## Executive Director's Recommendation

Commission Meeting: March 1, 2018

<b>PROJECT</b> <b>Embassy of Singapore - Fence Alterations</b> International Chancery Center 3501 International Place, NW Washington, DC	<b>NCPC FILE NUMBER</b> 7952
<b>SUBMITTED BY</b> United States Department of State	<b>NCPC MAP FILE NUMBER</b> 72.10(38.00)44684
<b>REVIEW AUTHORITY</b> Approval of Projects at the International Center Center per Section 4 of the International Center Act (Public Law 90-553, amended by Public Law 97-186)	<b>APPLICANT'S REQUEST</b> Approval of preliminary and final site development plans
	<b>PROPOSED ACTION</b> Approve preliminary and final site development plans
	<b>ACTION ITEM TYPE</b> Consent

EMBASSY OF SINGAPORE  
RENDERING OF FENCE UPGRADE  
FACING NORTH, TOWARD SOUTH WALL,  
INTERNATIONAL PL

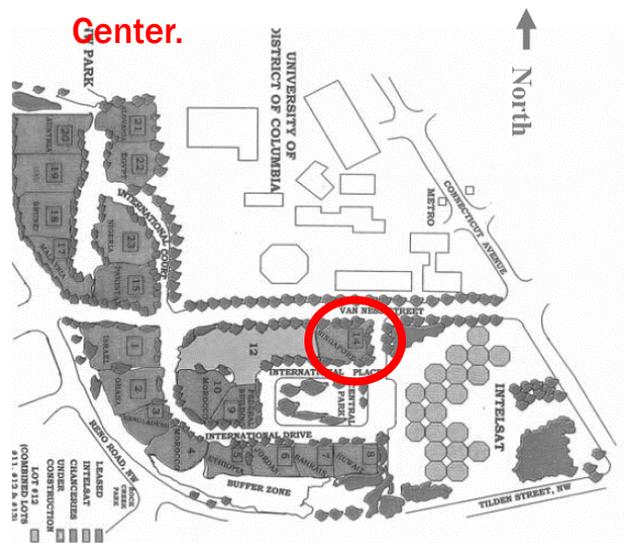
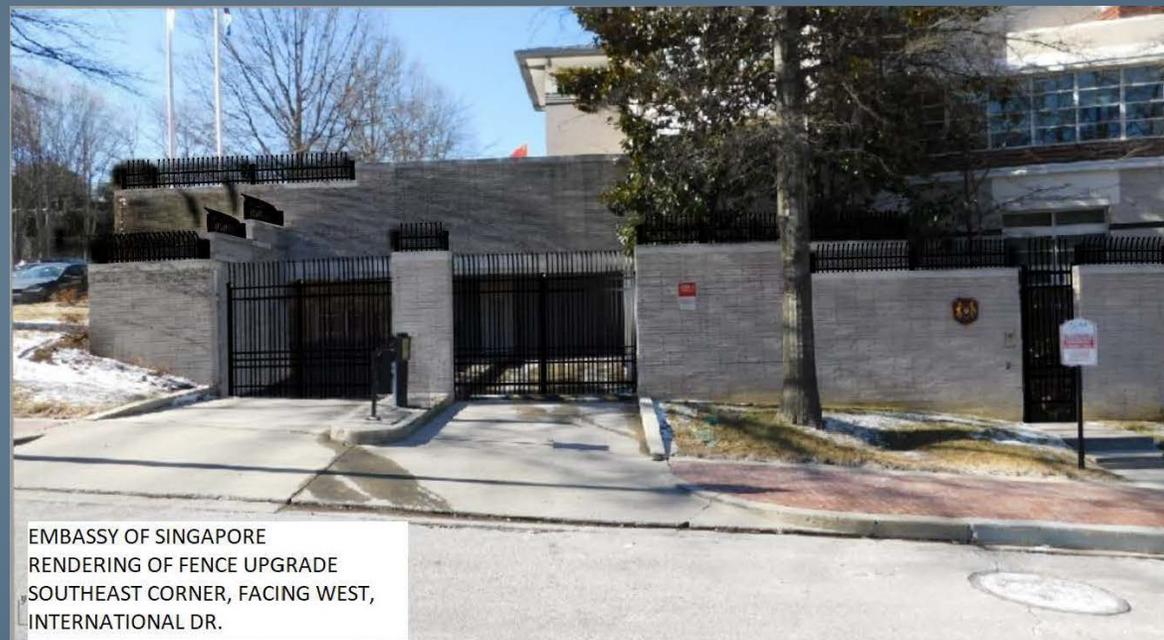
DOS has committed to the following design revisions:

- Maintain the vine-covered perimeter walls and provide additional landscaping to mitigate the height increase of the proposed fencing.
- Revise the design of the fence to gracefully step down to follow the topography while maintaining a maximum height of nine feet ten inches (9'-10") to be consistent with the Embassy of the People's Republic of China directly to the west and the overall character of the International Chancery Center.

EMBASSY OF SINGAPORE  
RENDERING OF FENCE UPGRADE  
SOUTHEAST CORNER, FACING WEST,  
INTERNATIONAL DR.

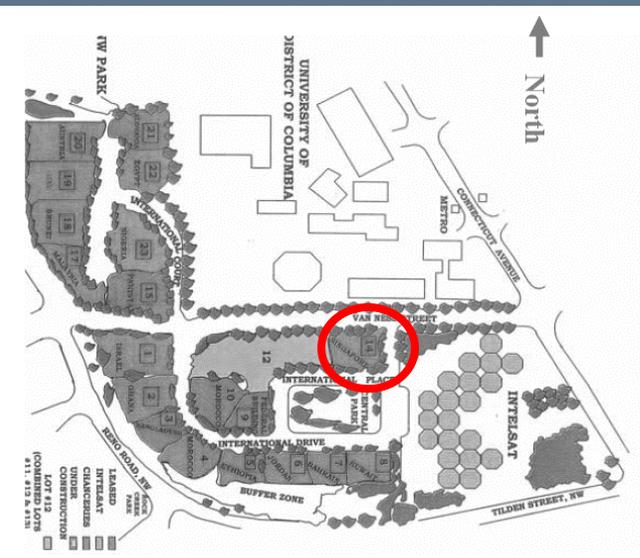
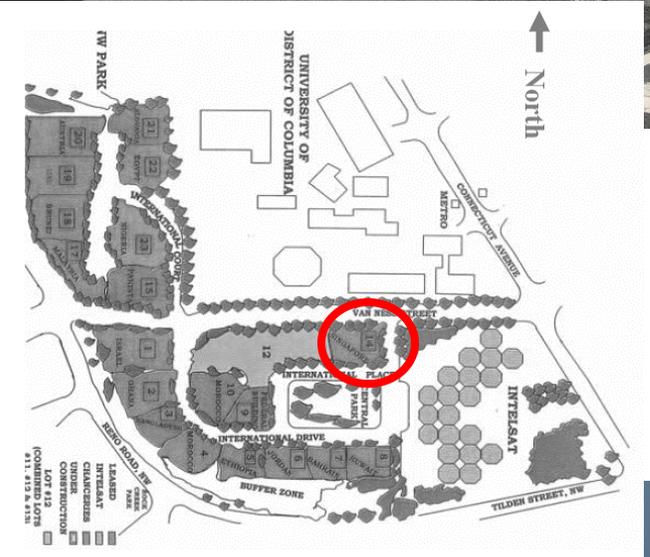
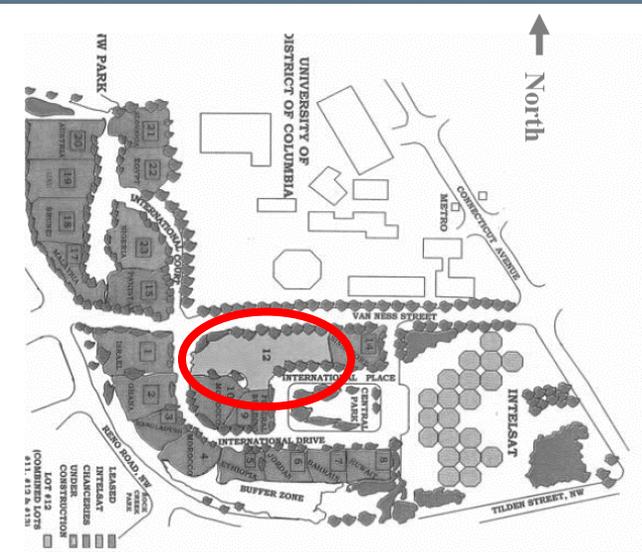
**DOS has committed to provide additional landscaping to mitigate the height increase of the proposed fencing**

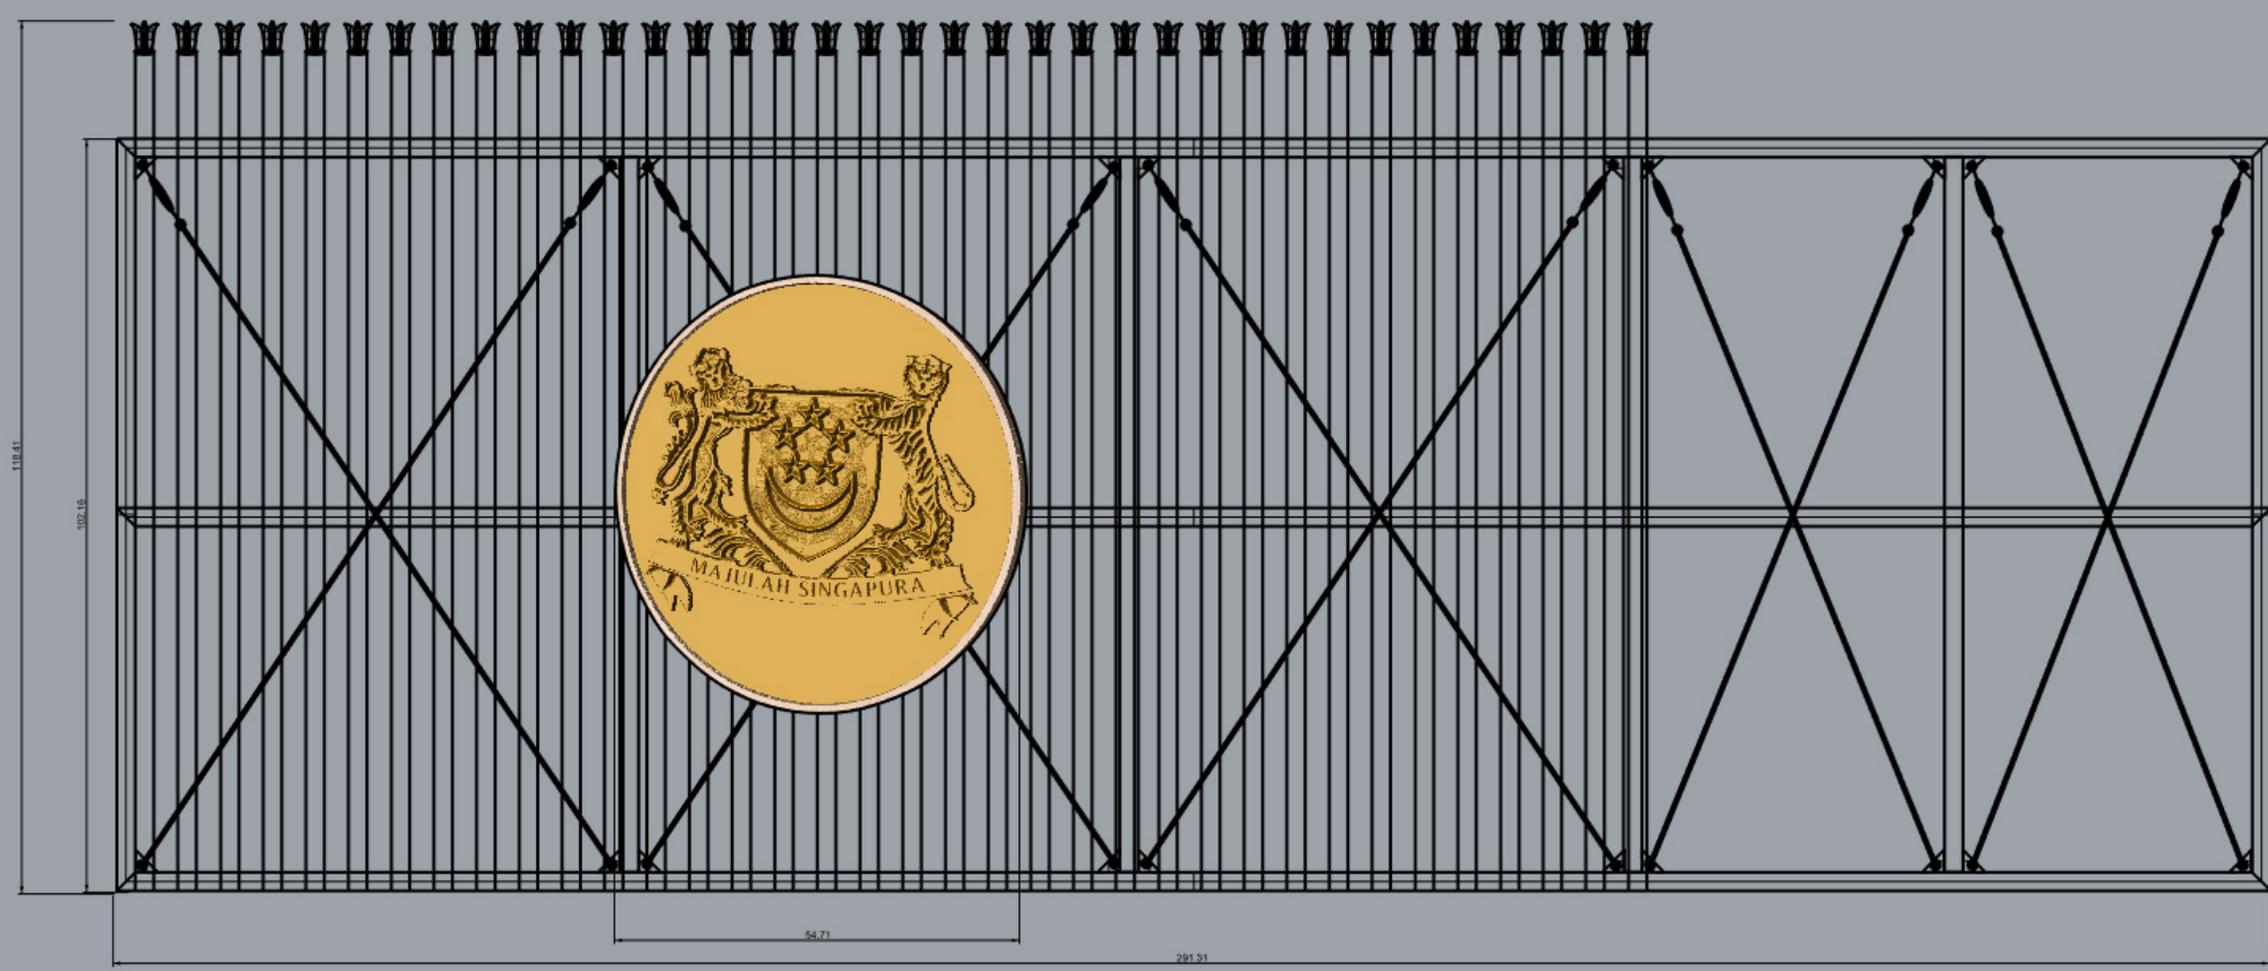
The Department of State will further study the location and scale of the proposed code of arms, and consider placing it on a solid perimeter wall to be more consistent with other chanceries within the International Chancery Center.
